## Urgent Field Safety Notice

10819177, Rev. A

ADVIA Centaur®  
ADVIA Centaur® XP

### Improper Manual Loading of Sample Racks

**Figure 1. Sample Entry and Inprocess Queues**

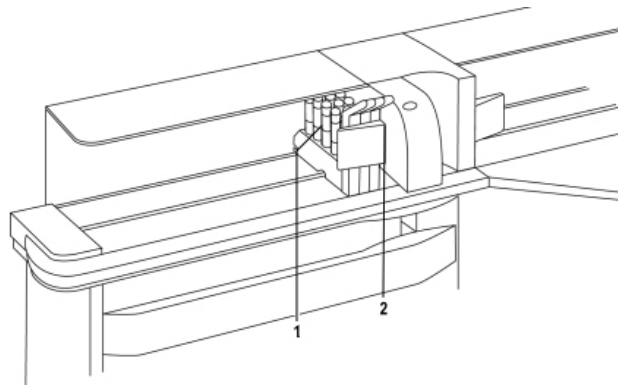
Pushing the sample racks may cause misreads of Sample IDs (SID) if the sample rack loading instructions are not followed exactly as described in the ADVIA Centaur or ADVIA Centaur XP Operator's Guide. Refer to Figure 1 in the Actions to be Taken by the Customer section.

If a sample rack is manually pushed with a slight forward nudge to the entry position without placing it on the rack positioning guide, the barcoded tube SID can be assigned to different positions in the rack. This may lead to misreported results.

When loading a sample rack, ensure the sample rack notch rests on the raised area of the sample entry queue (1) and the system automatically moves the rack to the loading position. This raised guide ensures the sample rack is positioned correctly and will accurately scan each barcode as it enters the inprocess queue (2). **Do not** push the sample racks into the system.
